The Chief Executive Officer
Northern Beaches Council
Attention: Ms Lashta Haidari

Development Application DA2020/0484
Additional Information Response
Frenches Forest Bushland Cemetery

Figure 1 - Approximately 1,900 to 2,000 square metres of land is needed to accommodate the proposed development

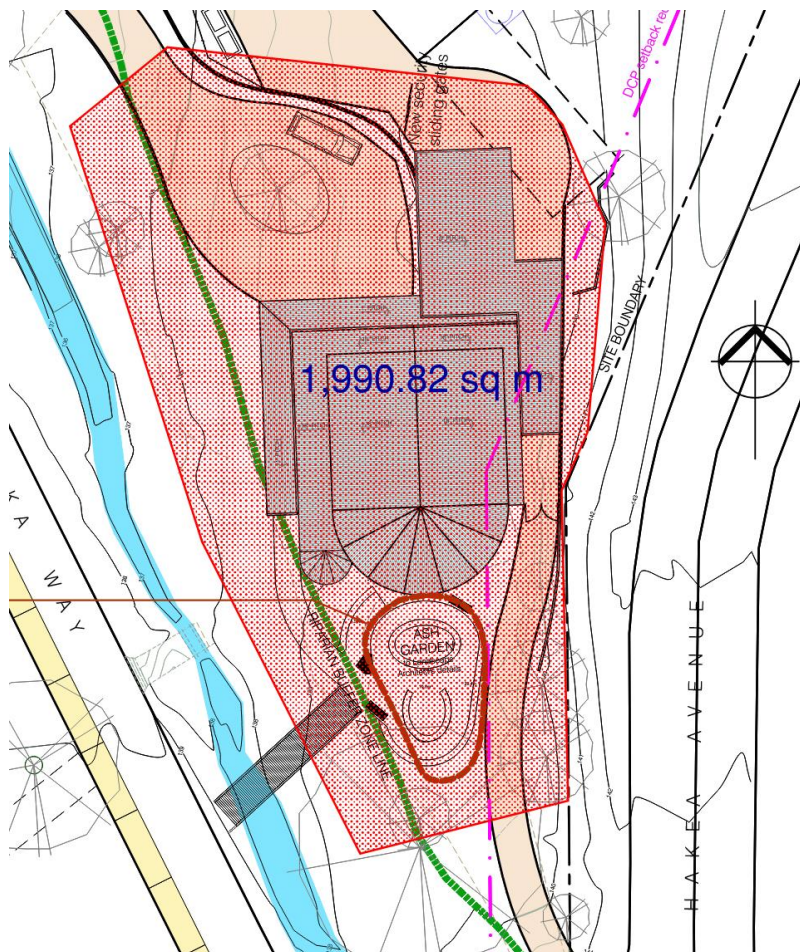
'The issue of the location of the Chapel building was raised. The asked for full analysis and justification to be provided as to why the chapel building cannot be located elsewhere in the site, if that the analysis found that this was the most suitable location, then are asking If the building could be moved (at all) towards the north to increase the front setback.

A successful chapel building that is fit for its purpose and valued by the community requires certain physical and spatial characteristics for it to function appropriately, meet its intended purpose and the satisfy the needs of the community. In summary, the chapel location requires the following characteristics:

1. Approximately 1,900 to 2,000 square metres of flat or moderately sloping land (see Figure 1 below).
2. 45 conveniently located car parking spaces which accommodates the carparking demand for the majority of funeral services.

Based on the above, the proposed Chapel cannot be located elsewhere in the site principally because there are no other contiguous areas of land that satisfy the physical and spatial characteristics required. These characteristics are profiles within Section 2 of this submission.
